# LOWER MINNESOTA RIVER WATERSHED DISTRICT

**Item 6. B. – 2024 T2 North Expansion Project – Rule D Amendment (LMRWD No.2024-006)**

# Technical Memorandum

**Re:** 2024 T2 North Expansion Project – Rule D Amendment (LMRWD No. 2024-006)

### MSP - TSS Compliance Summary (19,520 kg/day calendar month average limit)

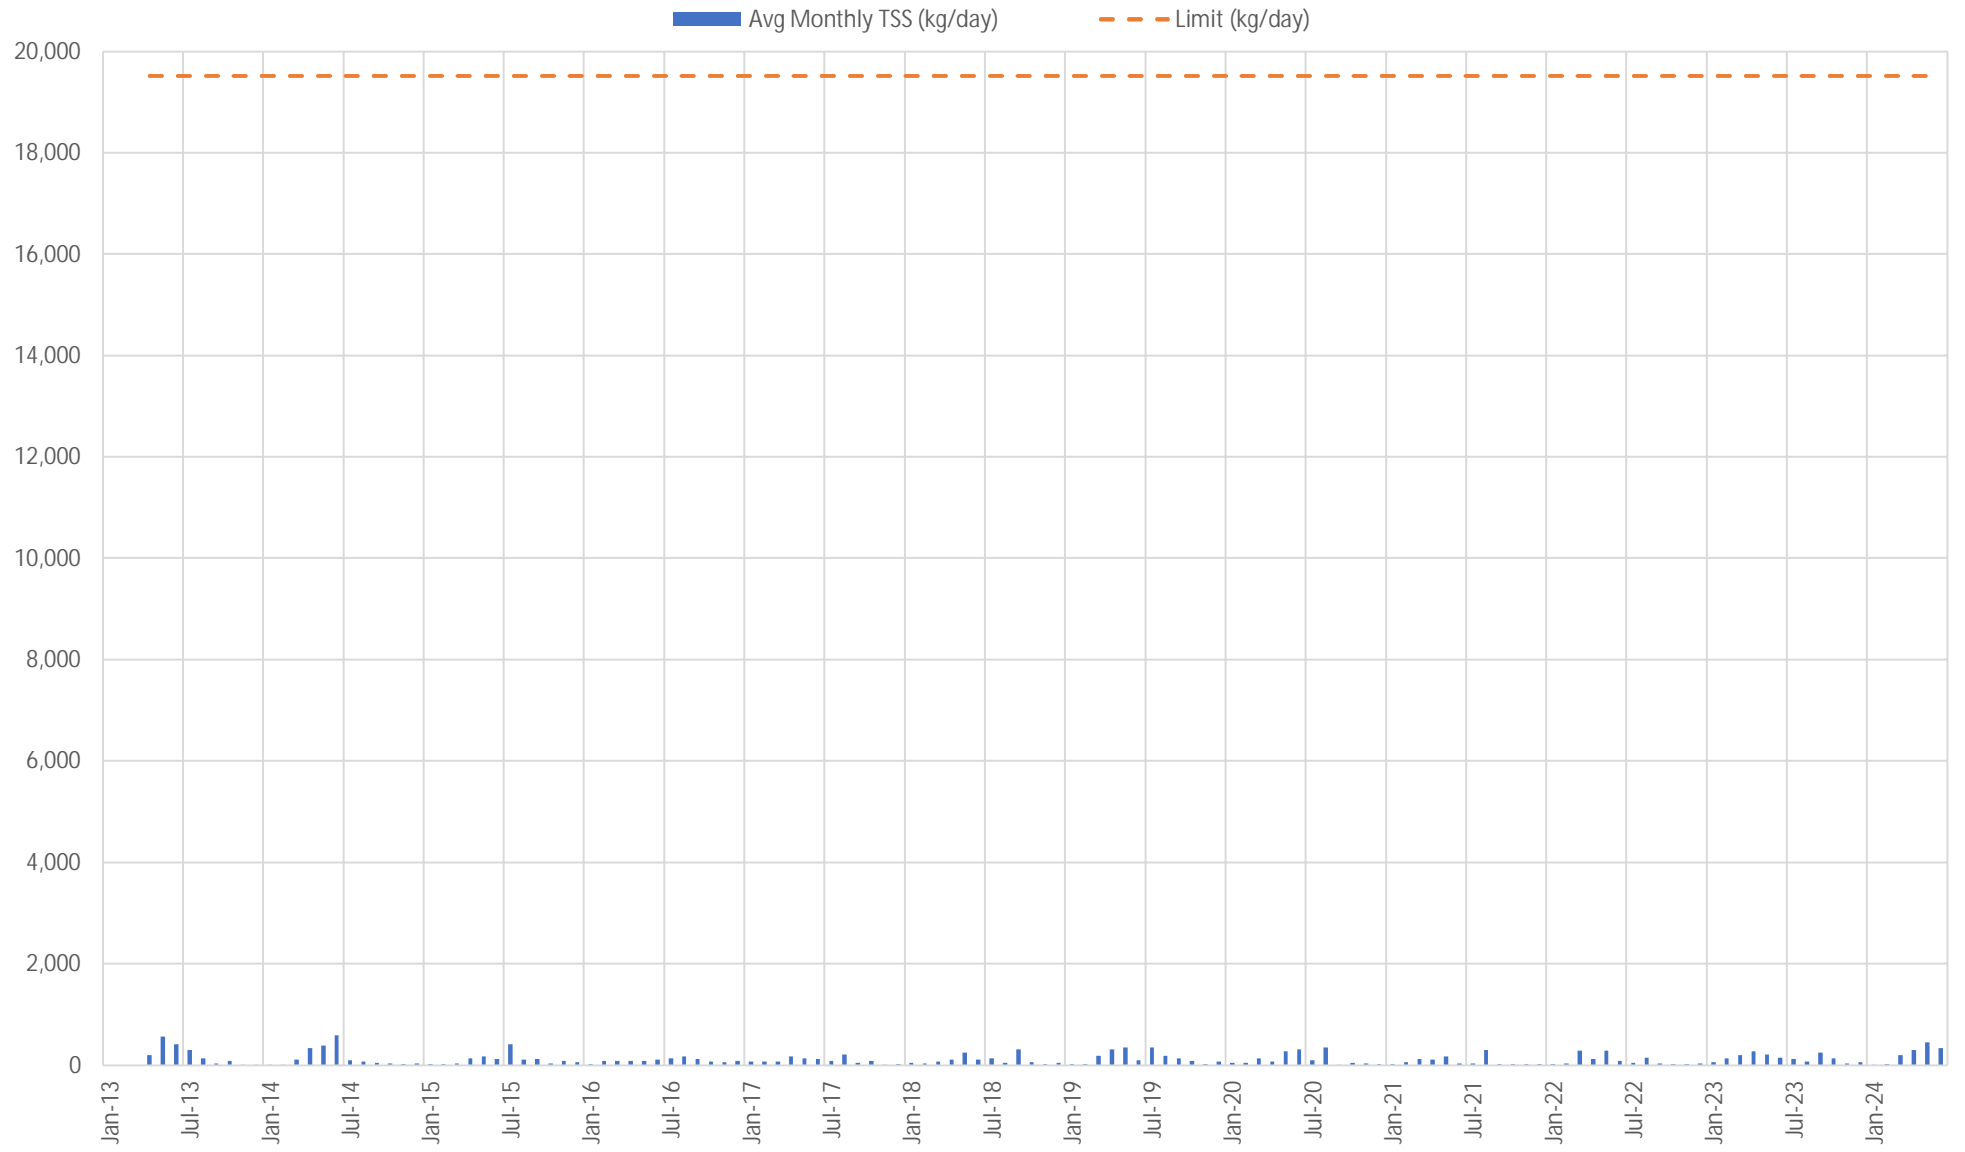
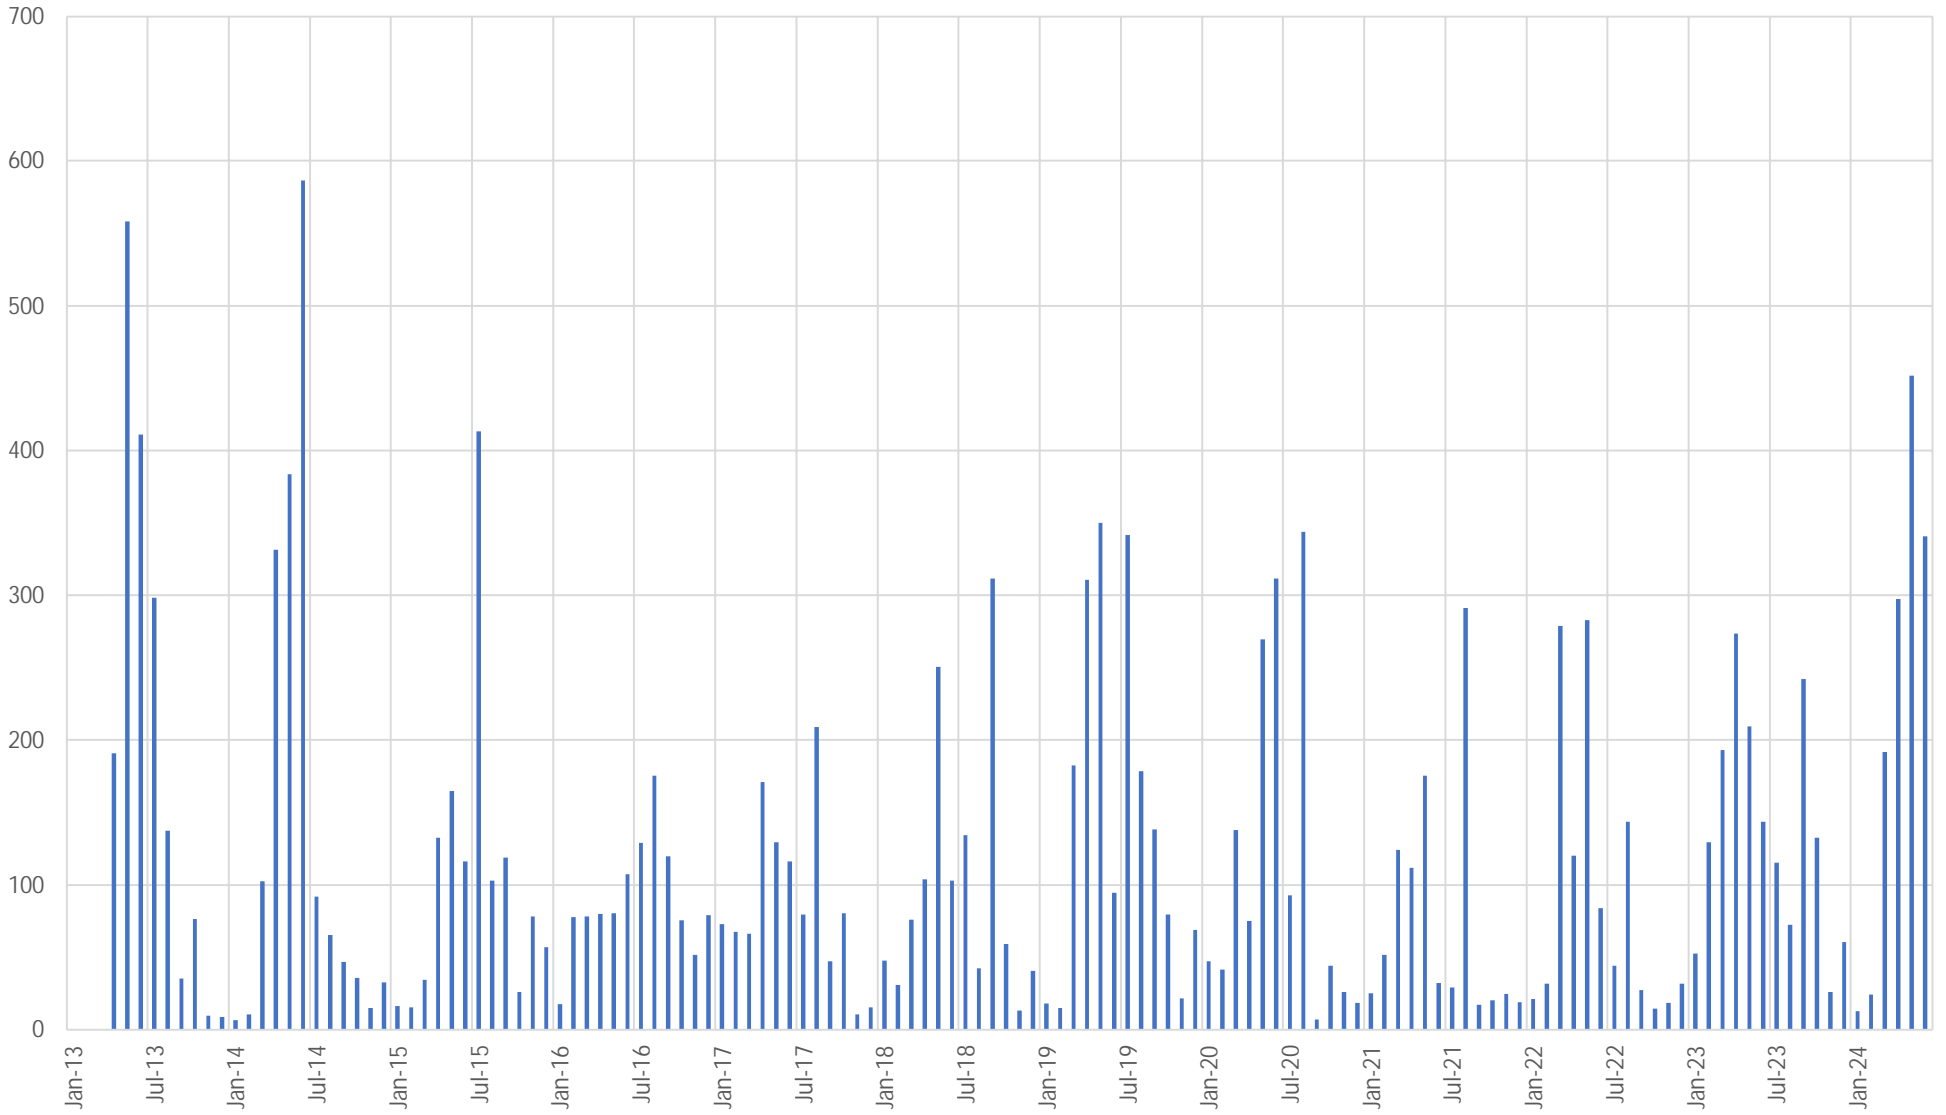
The applicant is proposing to treat the remaining volume of runoff using existing MSP Pond 1. The applicant provided as-built grading information, pond maintenance and sediment removal information, and LiDAR data showing the existing conditions of MSP Pond 1. Currently, MSP is authorized to discharge stormwater under the airport’s NPDES Permit MN0002101. This permit requires monitoring and effluent limits for TSS and TP, which includes monitoring discharge from the MSP stormwater ponds to the Minnesota River. The effluent limits for TSS and TP are stricter than LMRWD rules. The charts in Attachment 1 show that the airport has remained under the effluent limits for both TSS and TP since their permit was issued in 2013.

As presented, MSP Pond 1 has been properly maintained throughout the years and reduces pollutant loading for both TSS and TP, meeting the requirements of Rule D.
